### Planning - Case Comments

**Project Number:** PR-2022-007999

**Project Name:** 1700 Unser Blvd. NW

**Request:** EPC final sign-off

...336 Woodward site lighting...

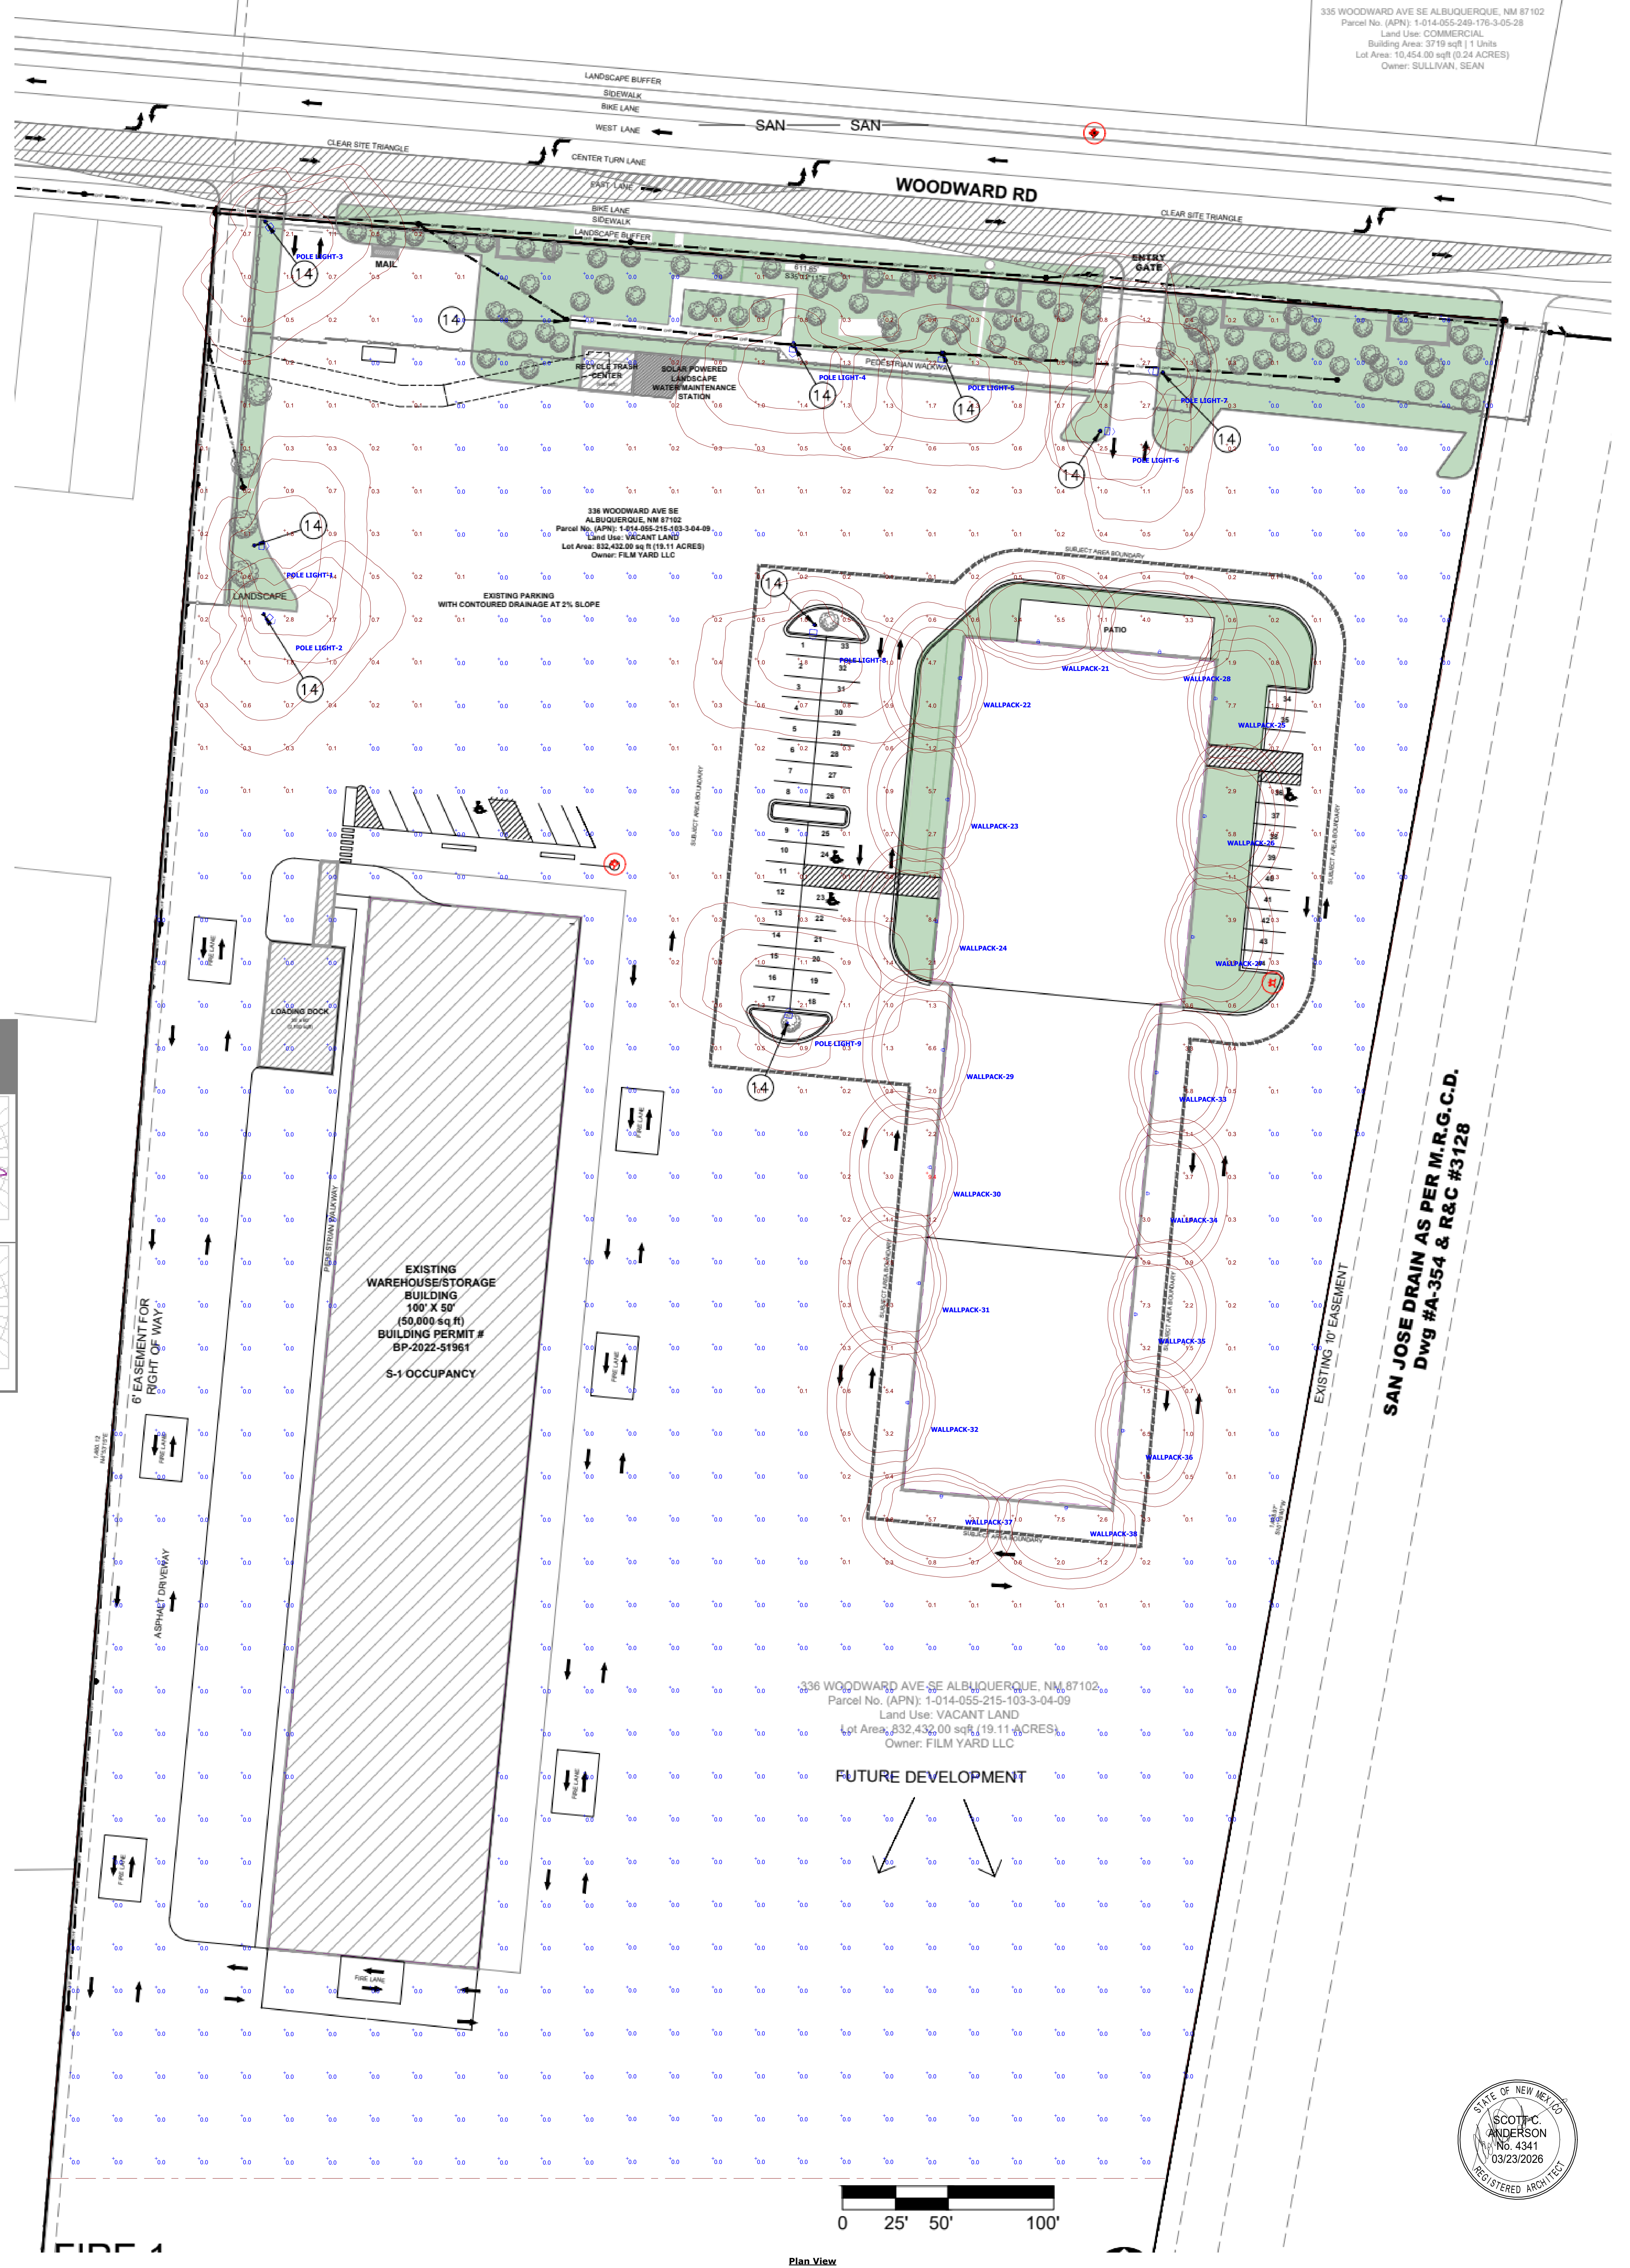
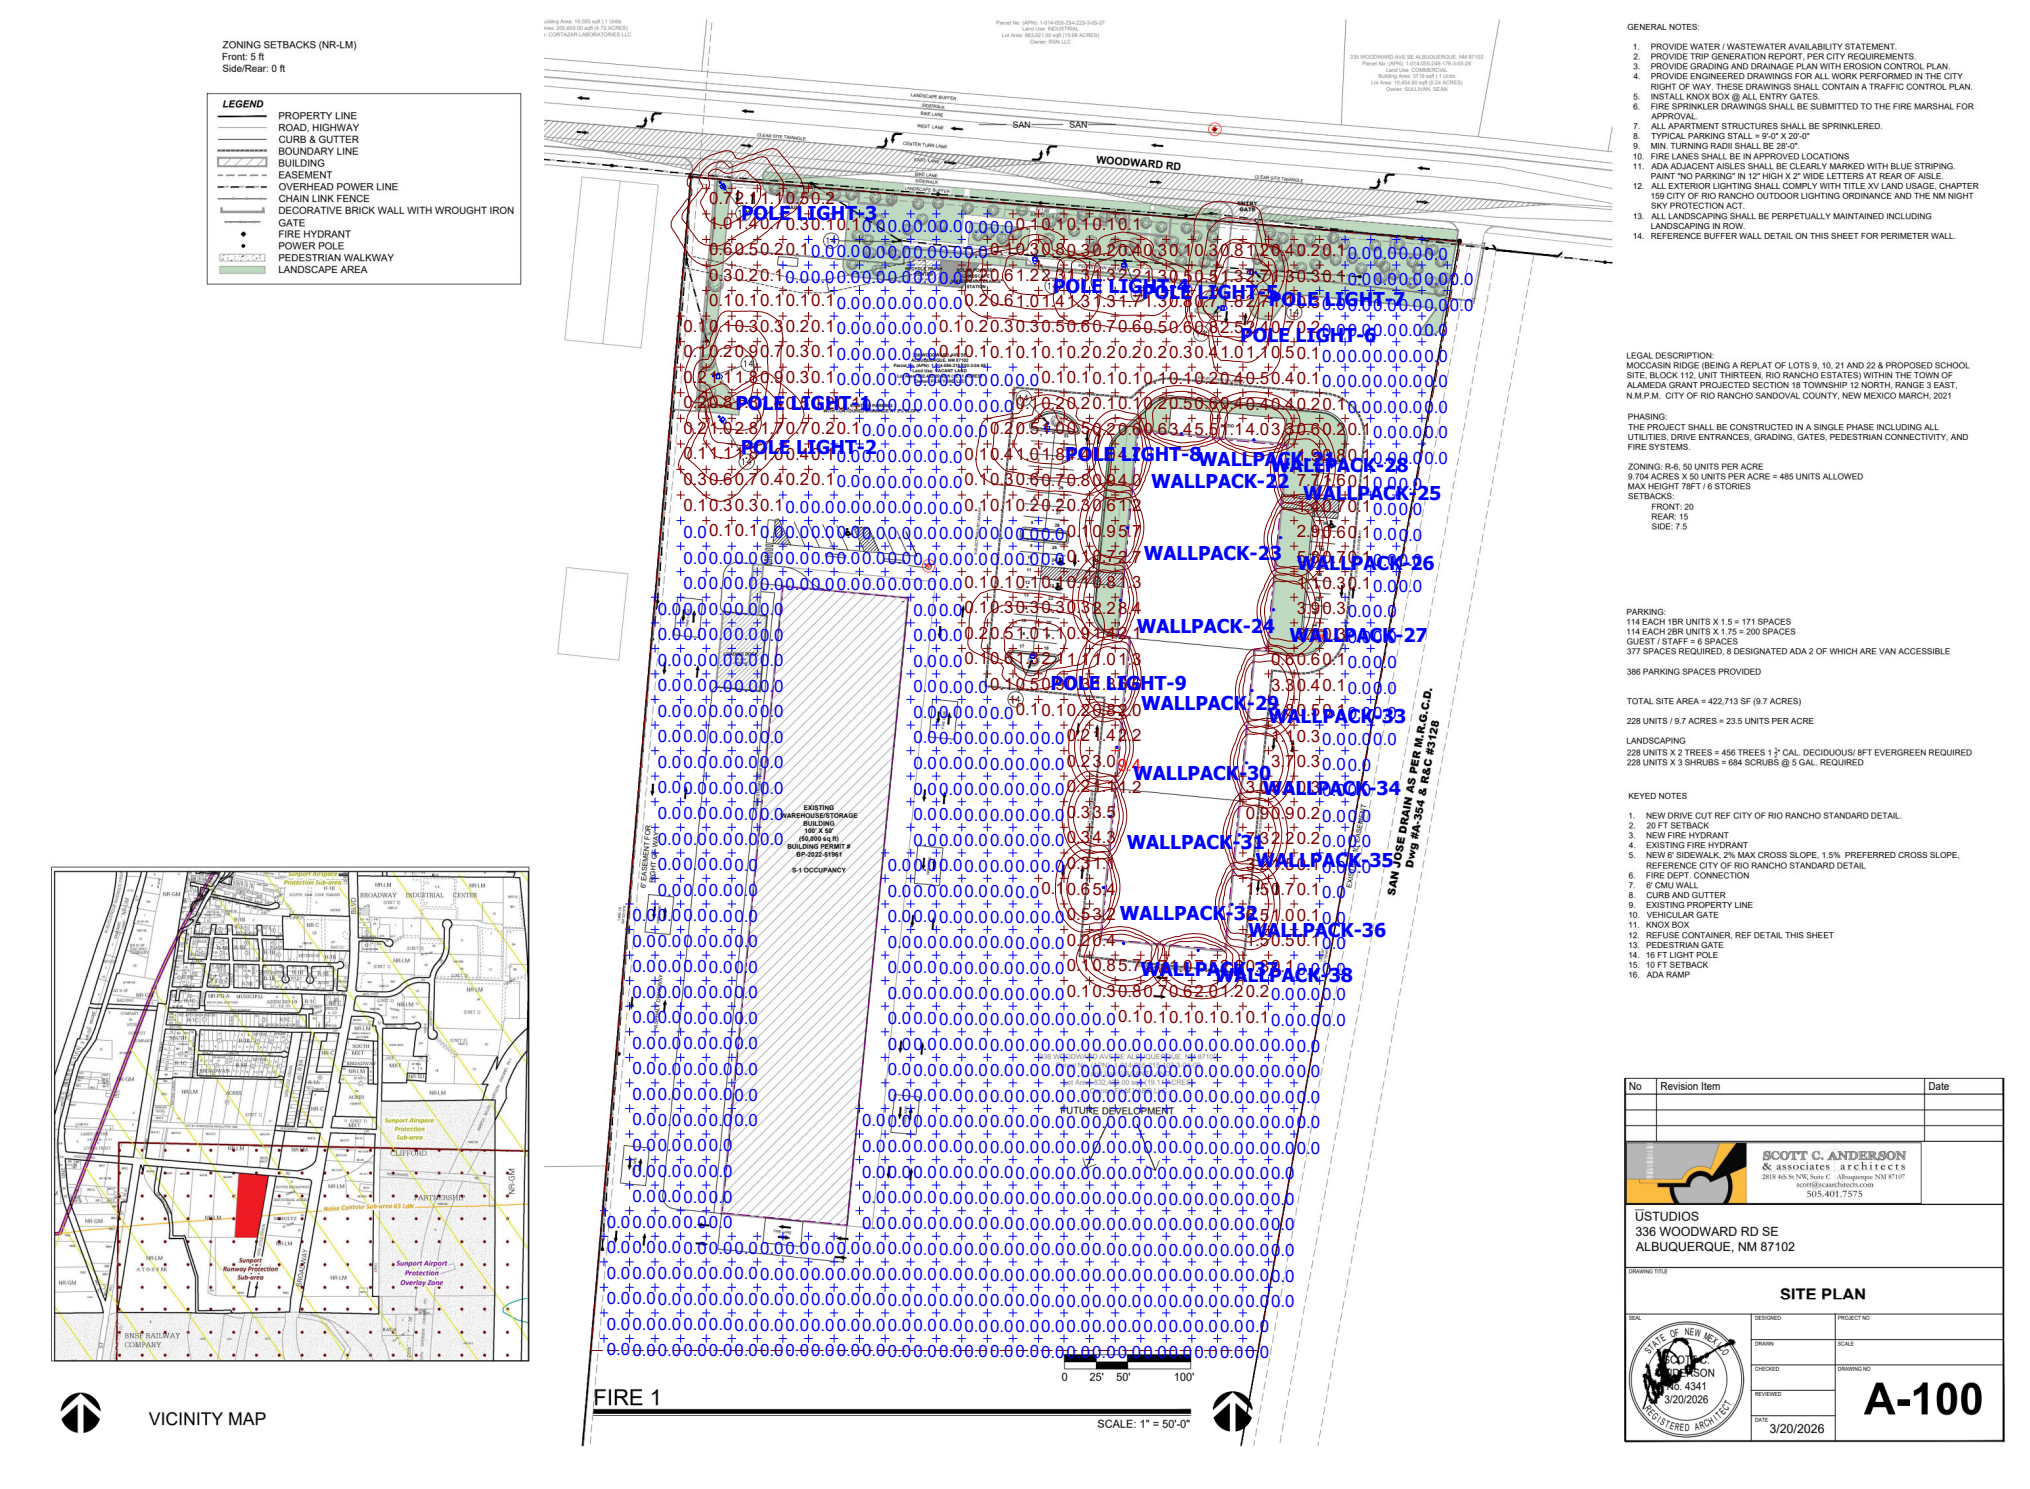
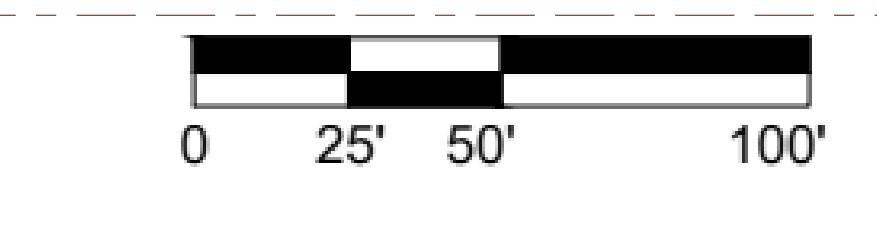
Proposed new development will trigger IDO 5-8 Outdoor and Site Lighting requirements for the property. Provide proper documentation to show how it will meet the requirements of IDO 5-8, including:

a) Light Detail sheets to show how lighting meets requirements of 5-8(E) General Design and Illumination Standards: pay particular attention to 5-8(E)(1) regarding uplight restrictions and IDO 5-8(E)(2), Correlated Color Temperature (CCT) and Color Rendering Index (CRI) standards.

b) Provide photometric lighting site plan to show how the development will meet light trespass restrictions, as per IDO 5-8(F)(4) Light Trespass and Tables 5-8-2 and 5-8-3.

Since new development will trigger 14-16-5-8 requirements, a Photometric lighting plan is provided to demonstrate that the site meets all standards for Design, Illumination Standards, and Restrictions on light direction, color temperature, and CRI. Attached.
